PROJECT TITLE: Drainage Plan 1921 Richmond NE H-16 ZONE ATLAS/DRNG. FILE #: H16/D119
 DRB #: 95-298 EPC #: _____ WORK ORDER #: _____
 LEGAL DESCRIPTION: Lot 4-B-1 in Block 1A, Miracerros Addition
 CITY ADDRESS: 1921 Richmond Drive NE
 ENGINEERING FIRM: DVC CONTACT: Debbie Cleft
 ADDRESS: 6212 Terrell NE PHONE: 2496196
Albuquerque, N.M. 87109
 OWNER: Bruce Caird CONTACT: Bruce Caird
 ADDRESS: 2425 San Pedro NE PHONE: 881-9696
 ARCHITECT: _____ CONTACT: _____
 ADDRESS: _____ PHONE: _____
 SURVEYOR: _____ CONTACT: _____
 ADDRESS: _____ PHONE: _____
 CONTRACTOR: _____ CONTACT: _____
 ADDRESS: _____ PHONE: _____

**RE: LOT 4-B-1 (H16-D119) DRAINAGE PLAN SUBMITTAL FOR FINAL PLAT APPROVAL.
ENGINEER'S STAMP DATED 7/2/96.**

RE: *Engineer's Certification for 1921 Richmond Dr. NE (H16/D119) Engineer's Stamp Dated 6/21/98.*

Re: Engineer's Certification for 1921 Richmond Dr. NE
(H16/D119)

PLAN AT SINGLE PIPE
(SKEWED INSTALLATIONS)

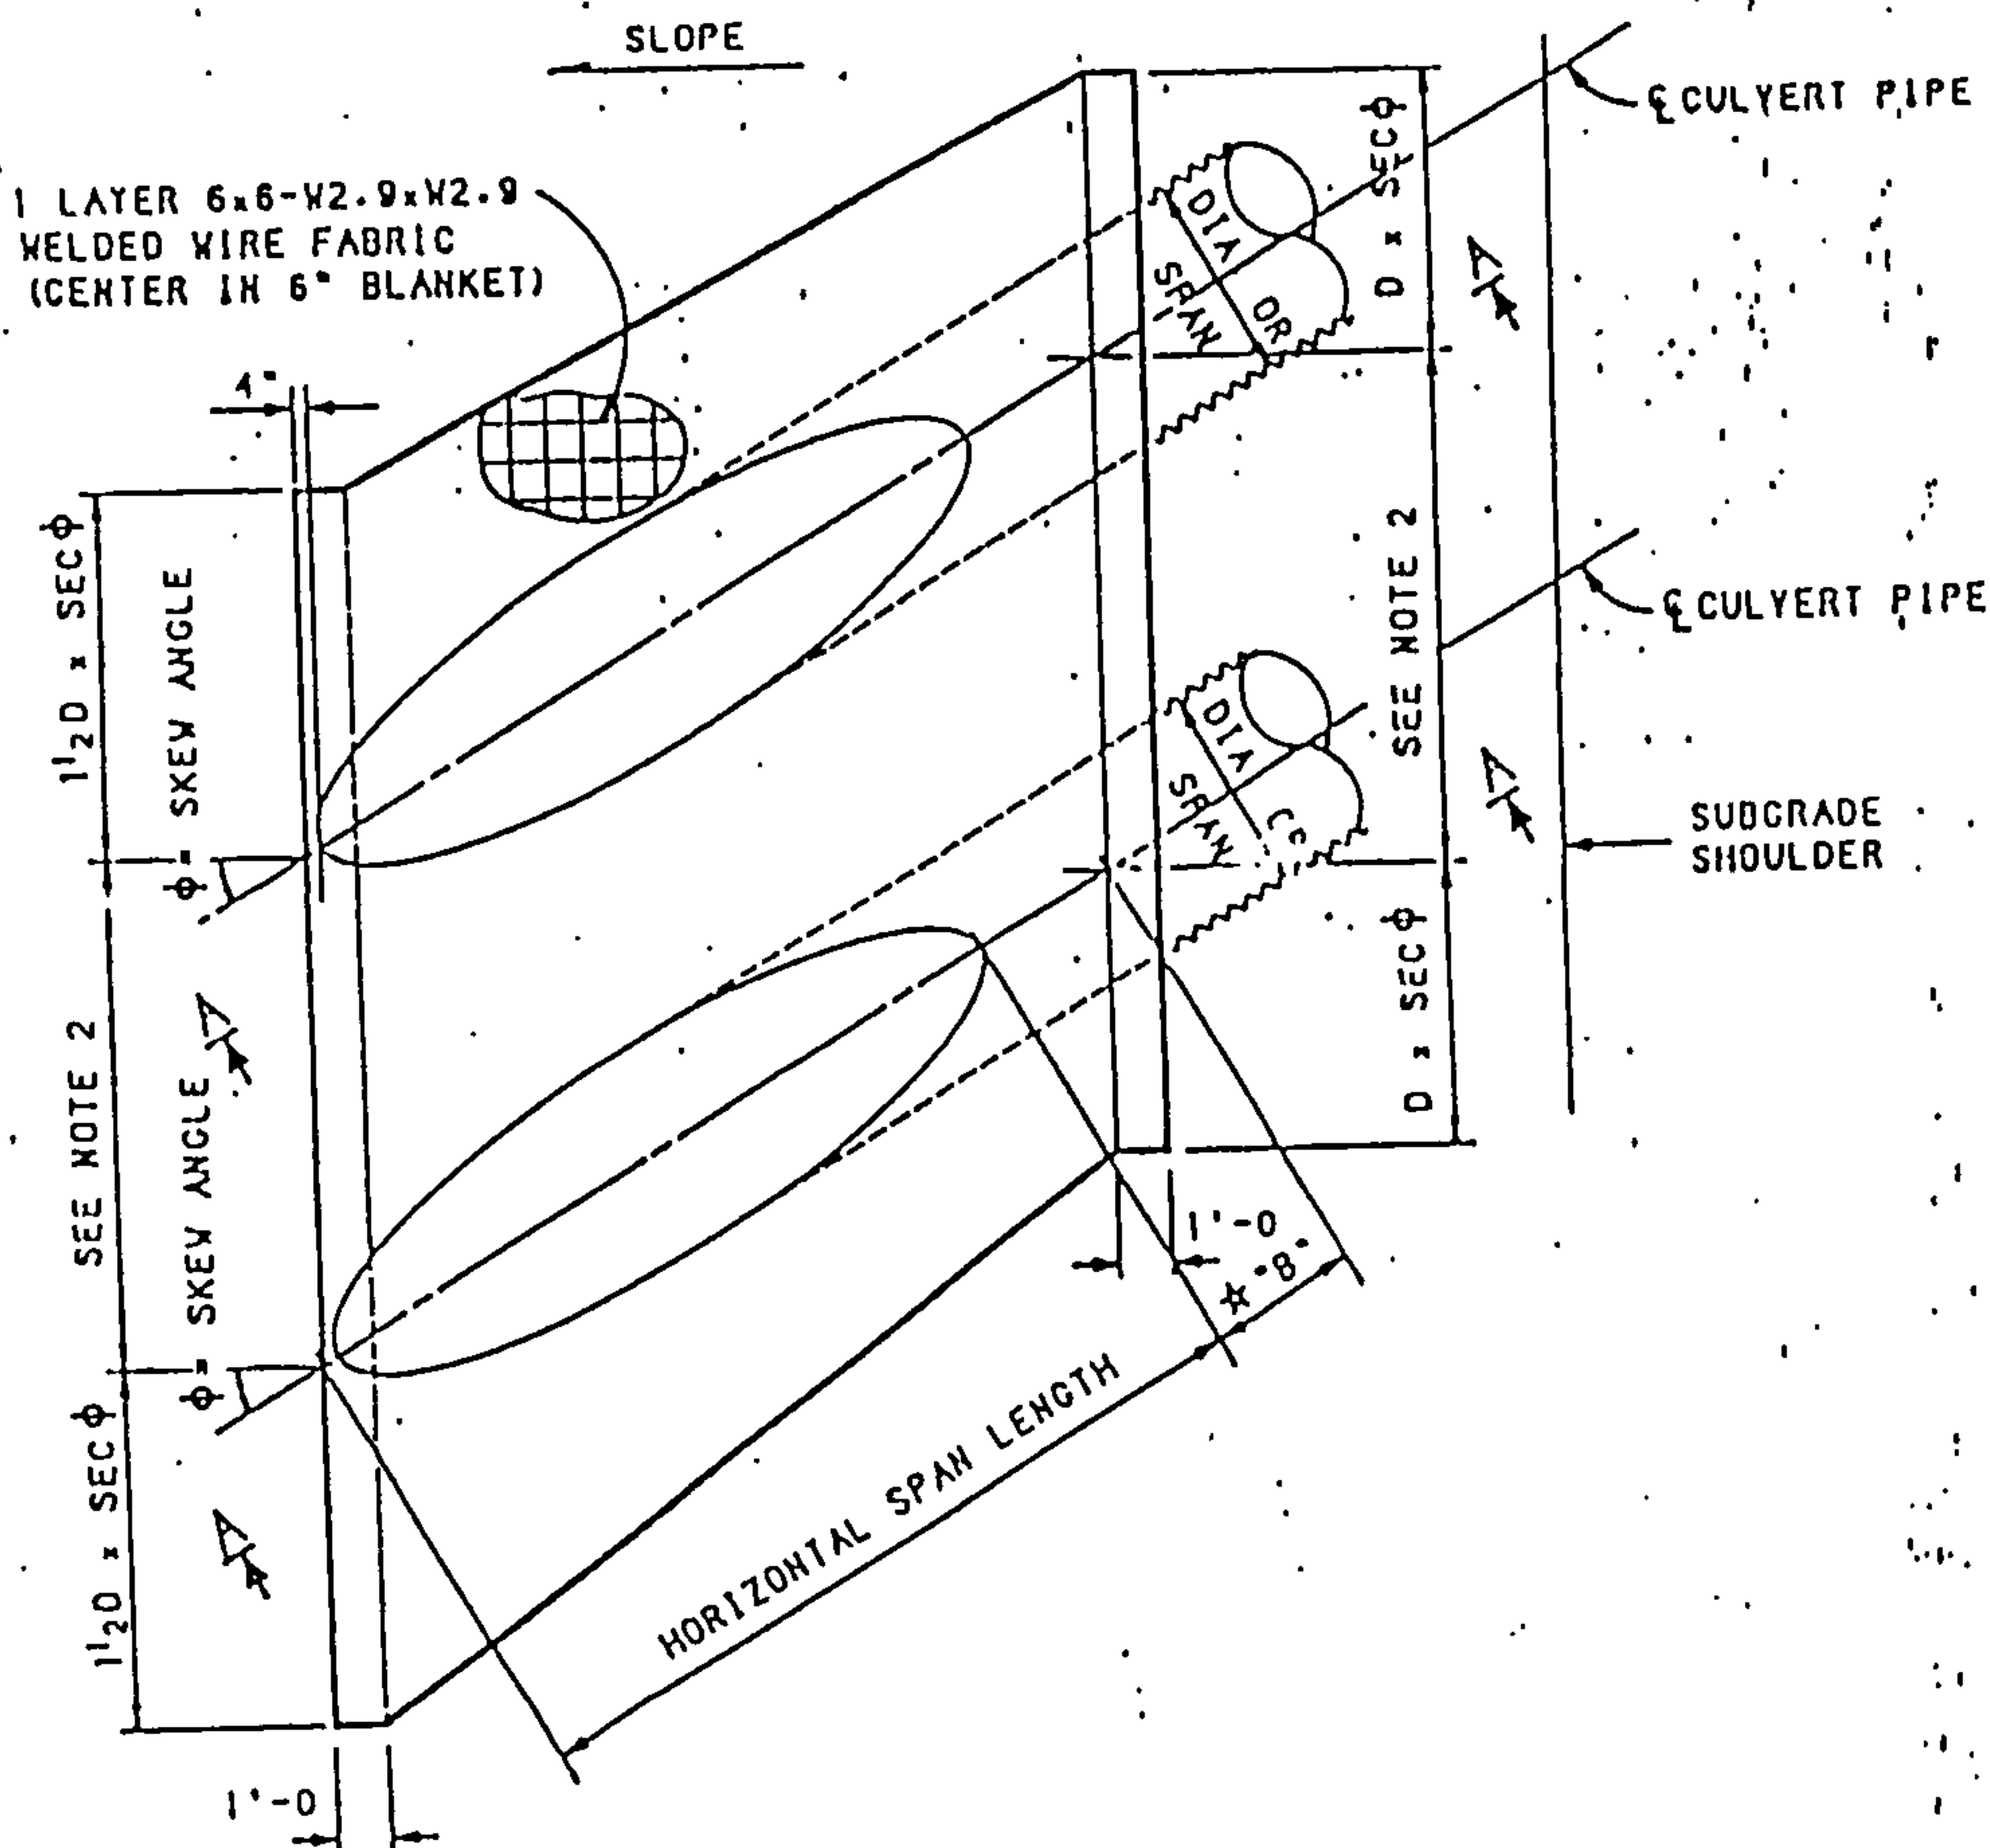
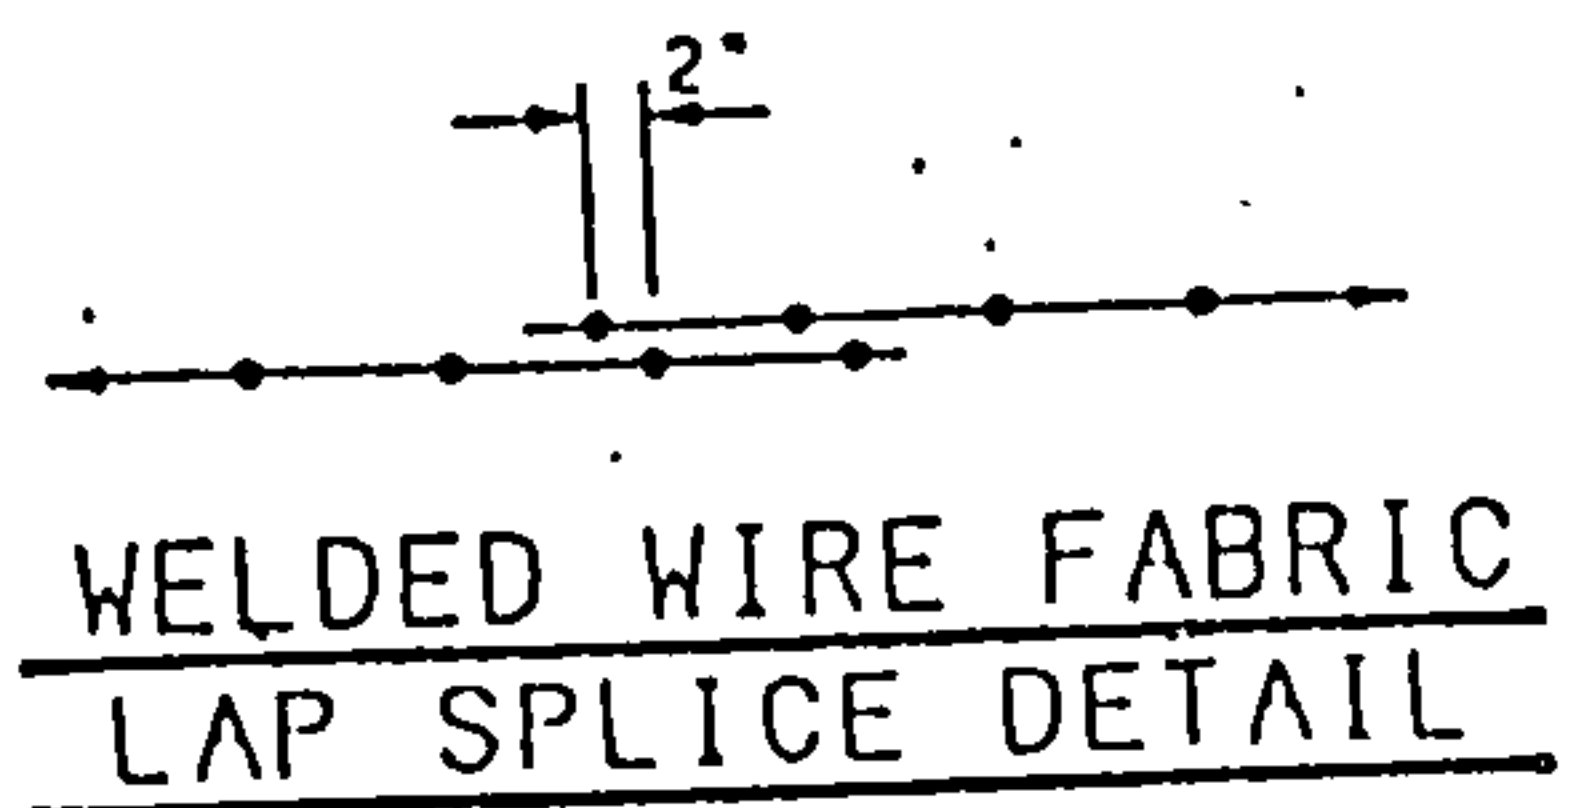
I received your letter and plan details for the 18" culvert extension at Richmond Avenue that drains into the State right-of-way. I concur with the recommendations; and your submittal addressed the May 19, 1998 comments.

However, I recommend to provide an elbow at the pipe extension so as not to direct the flow toward the driving lanes. Please keep the pipe extension as far from the pavement as possible and outside of the clear zone. The clear zone is 33 feet from the edge of the outside driving lane.

The comment was accepted by the property owner and will be constructed detailed with a bend to direct the flow parallel to the driving lanes. A permit has been requested from the District Three Office in Albuquerque to construction within the highway right-of-way and is expected soon.
